Approved Section 4.55 (1A) Modification

Approved Application No: SSD-10383-Mod-4 Sheet No: 1 of 24

PROJECT TYPE:
PROPOSED CHURCH

PROJECT ADDRESS:
2 DARCY ROAD
WESTMEAD 2145
LOT 1 IN DP 1095407

TITLE:
PARISH CHURCH FLOOR PLAN

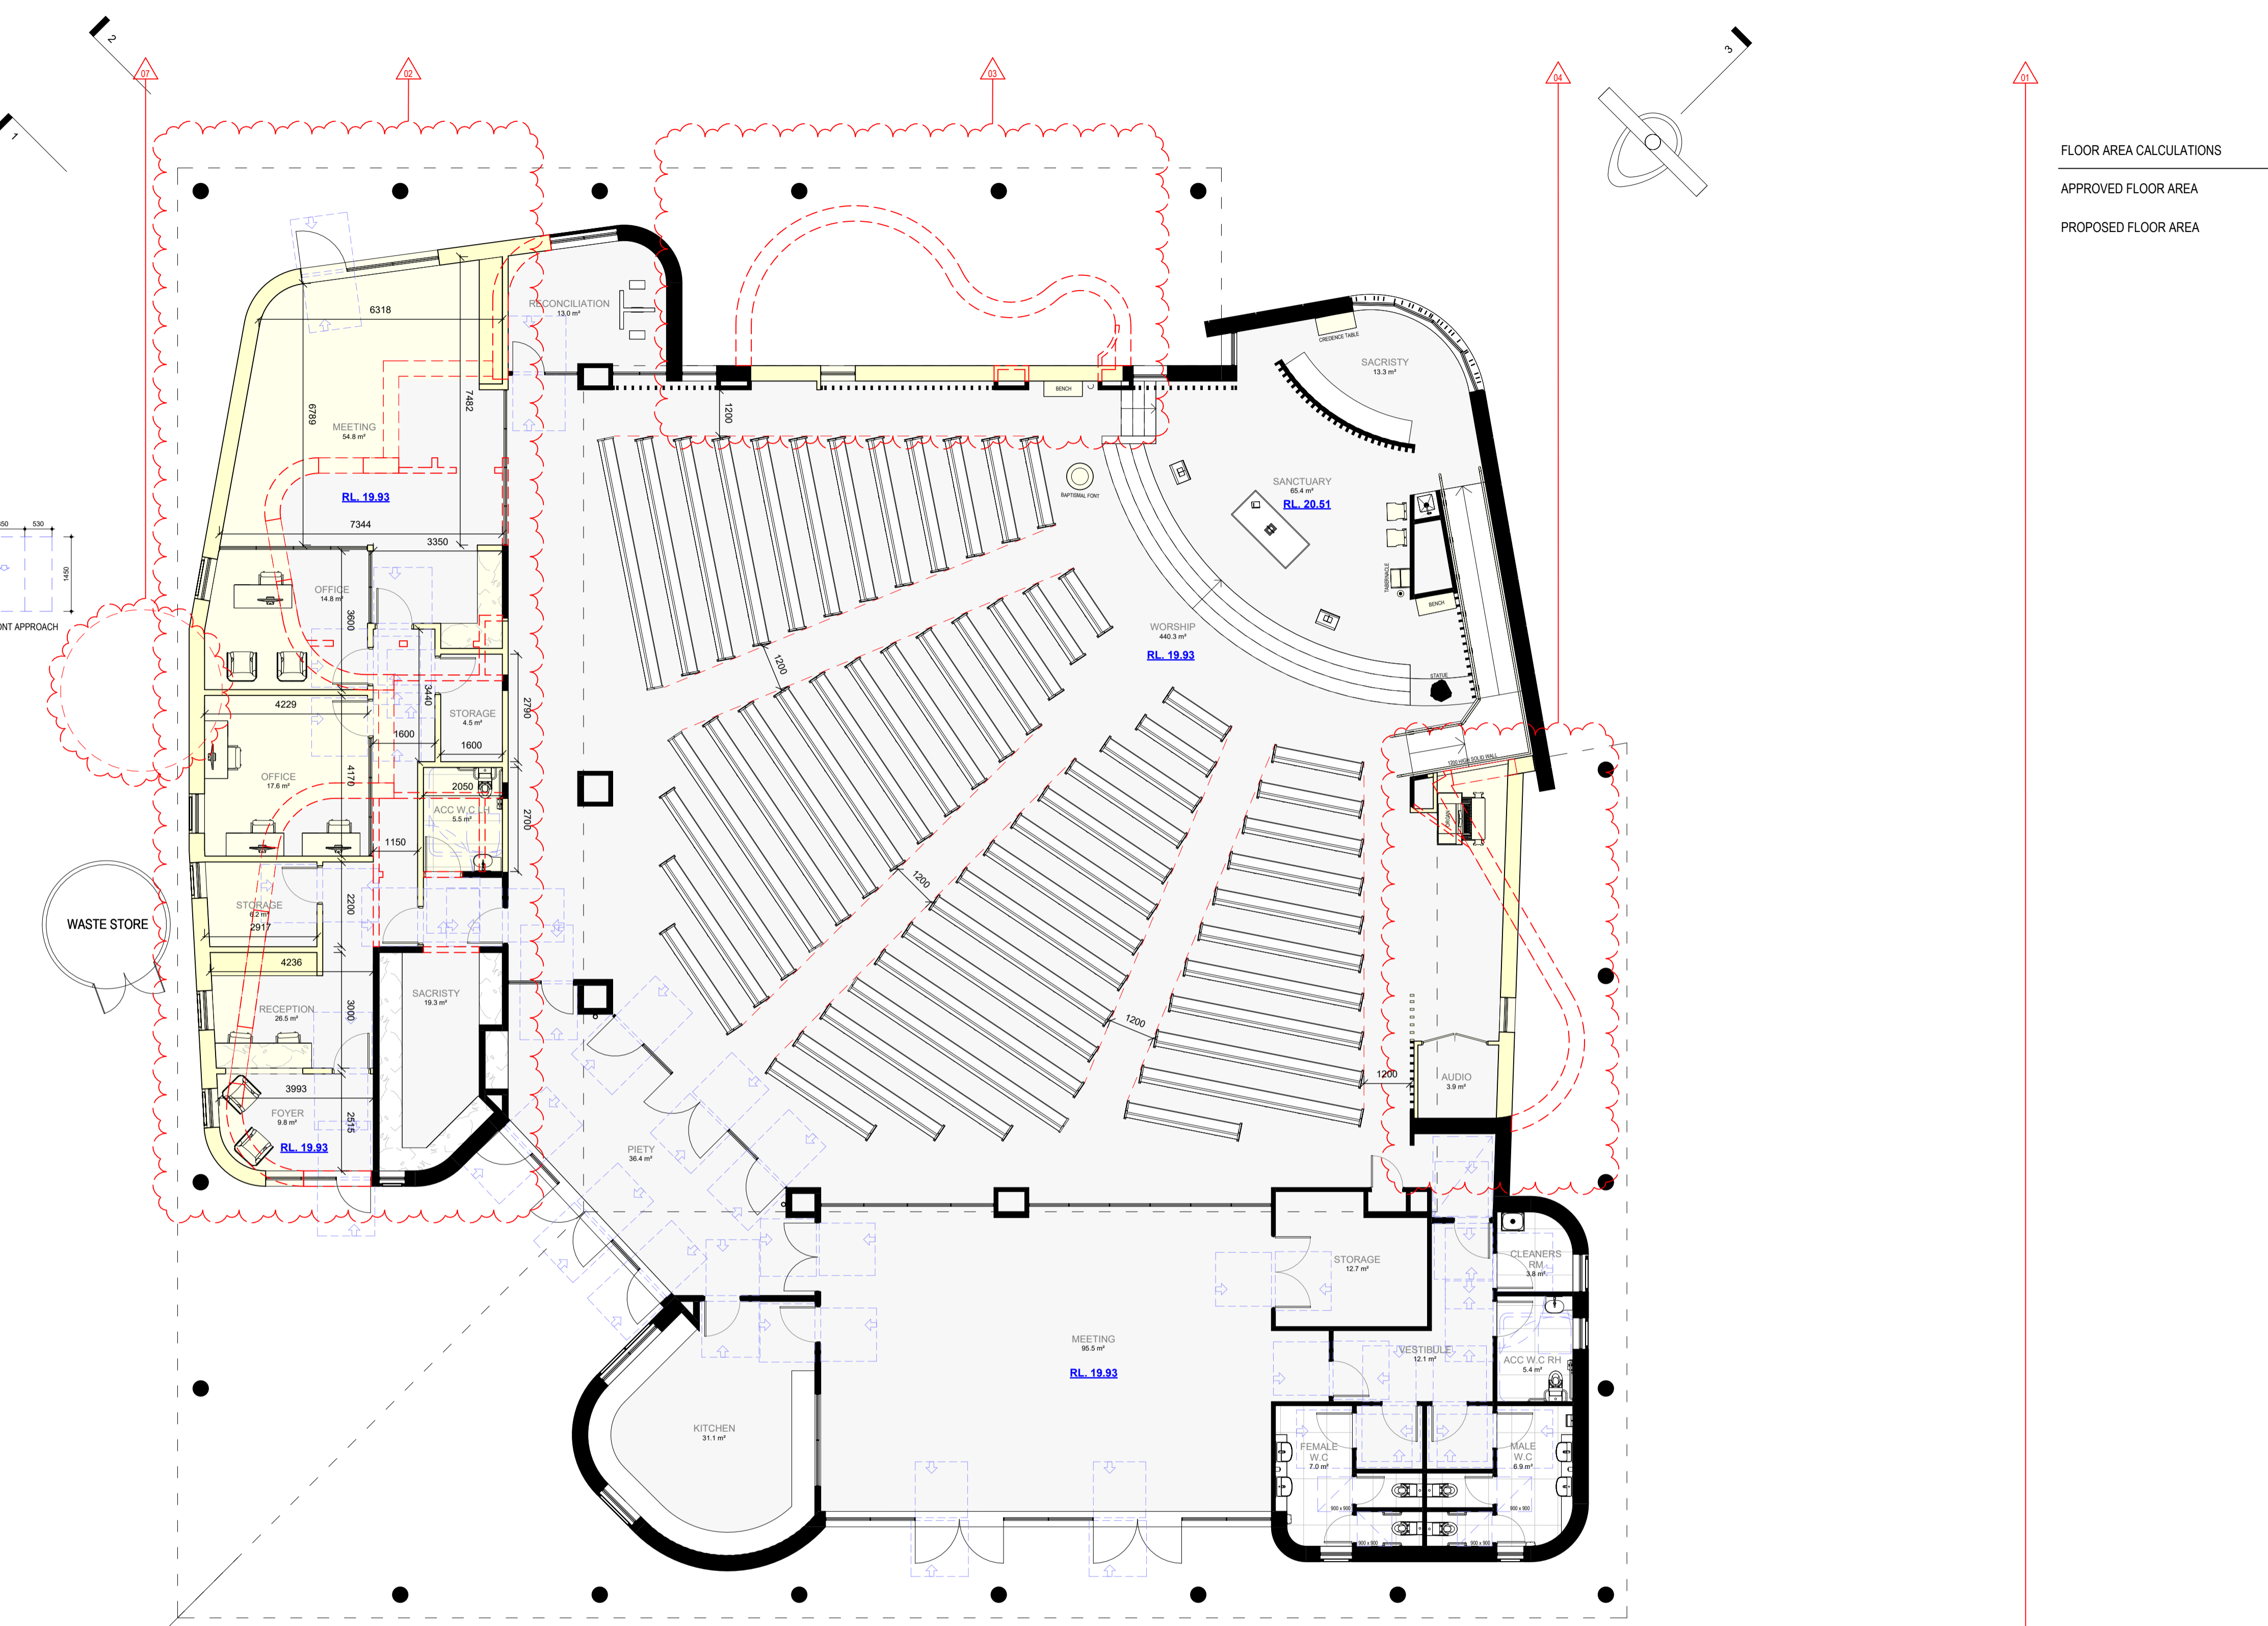
APPROVED FLOOR AREA	1005 m²
PROPOSED FLOOR AREA	948 m²

SECTION D
1:100

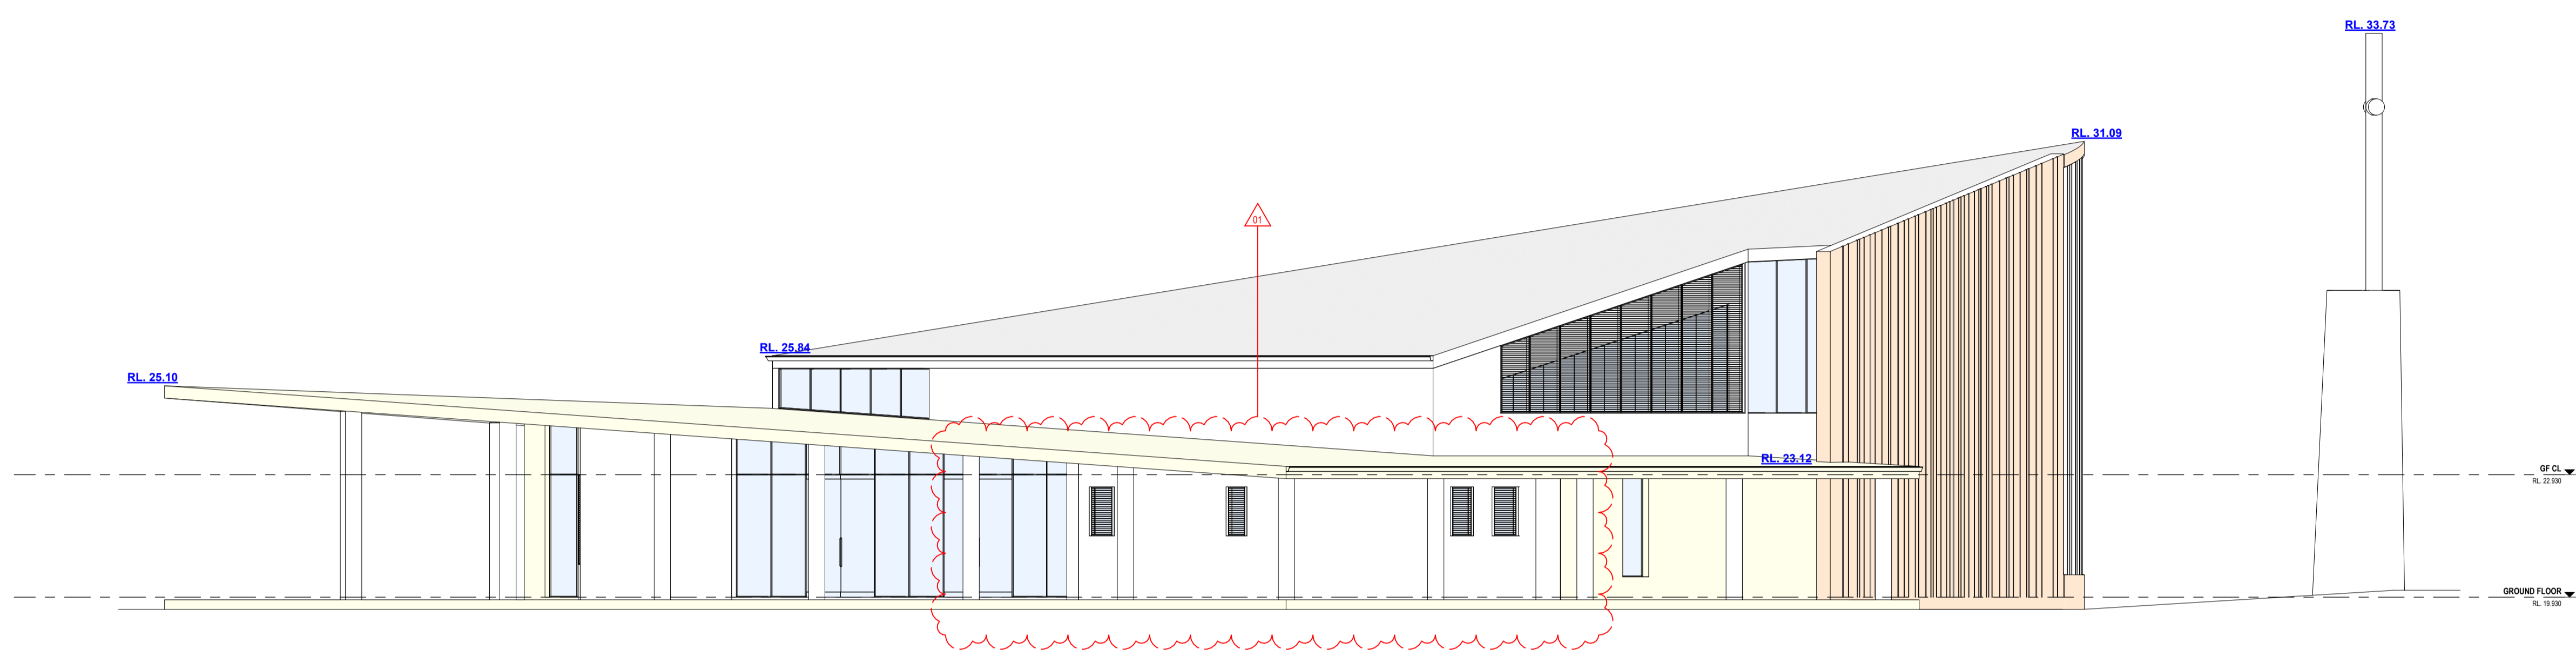
ADMIN BUILDING SECTIONS REMOVED

LANDSCAPE MASTERPLAN

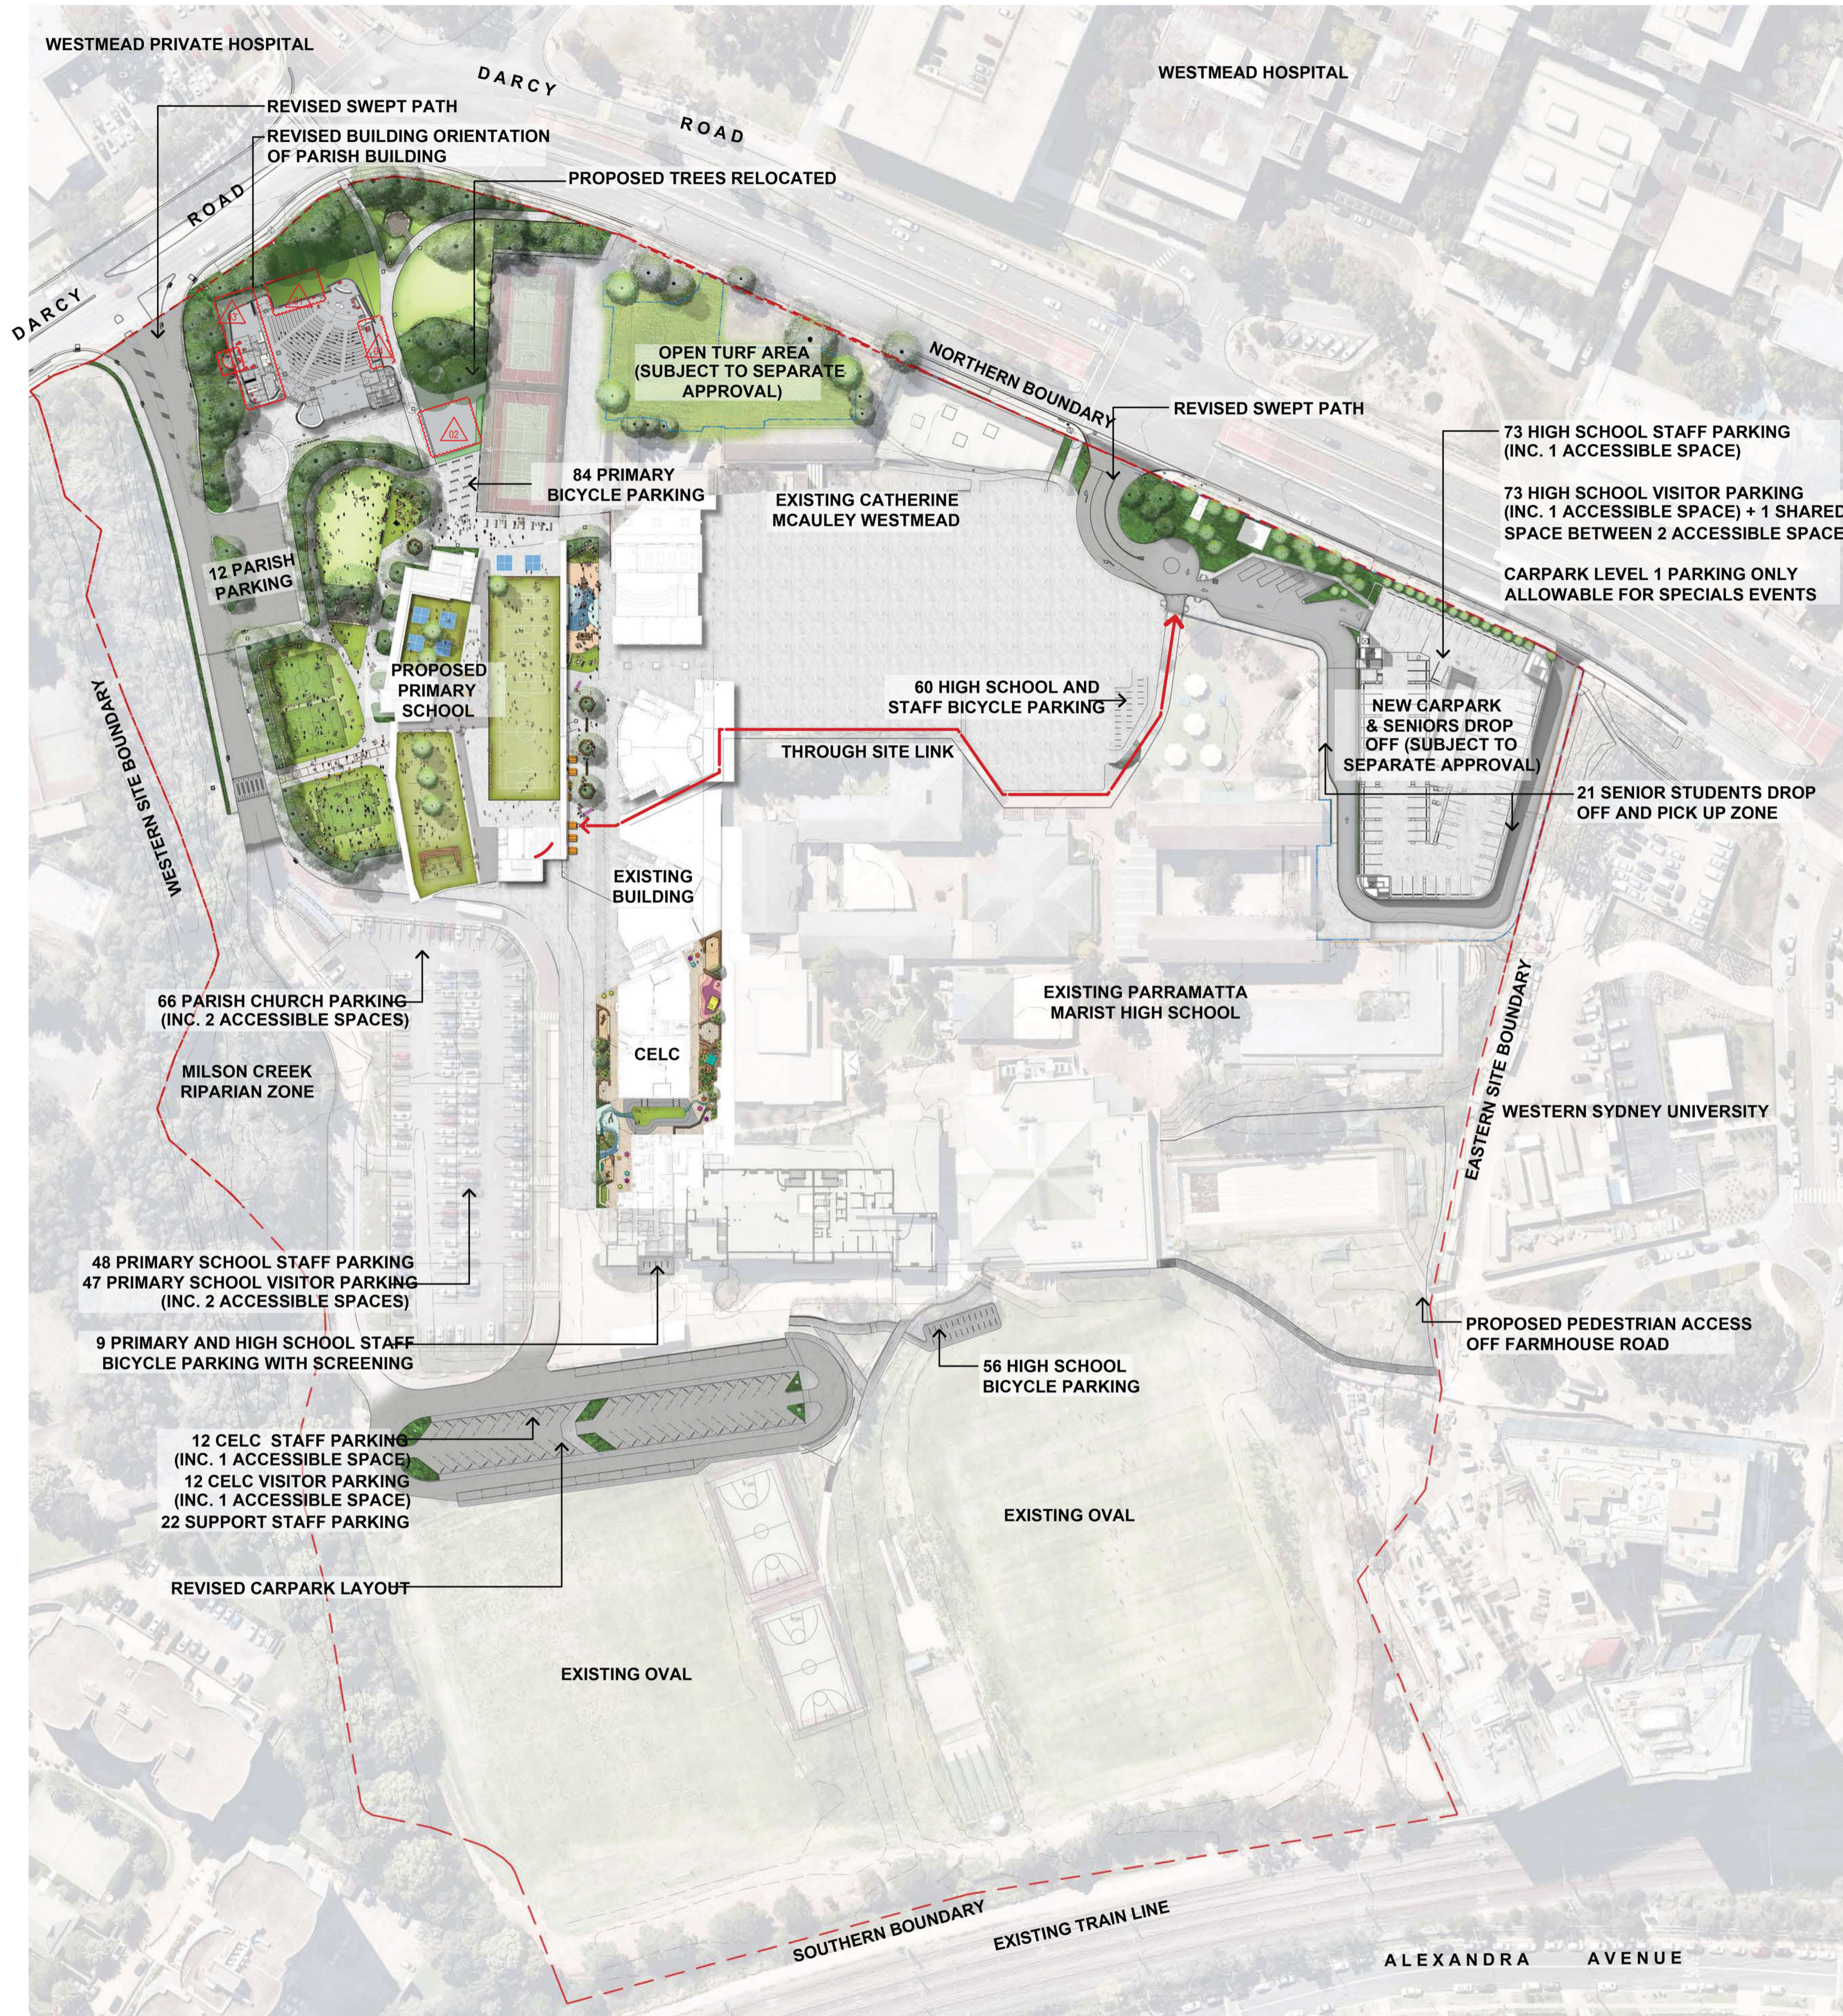
- LIST OF CHANGES**
1. PROPOSED LANDSCAPE AREA
 2. EXTENSION ON TURF AREA
 3. GARDEN BED INTRODUCED WITH A CONCRETE SLAB
 4. PROPOSED CONCRETE PATH
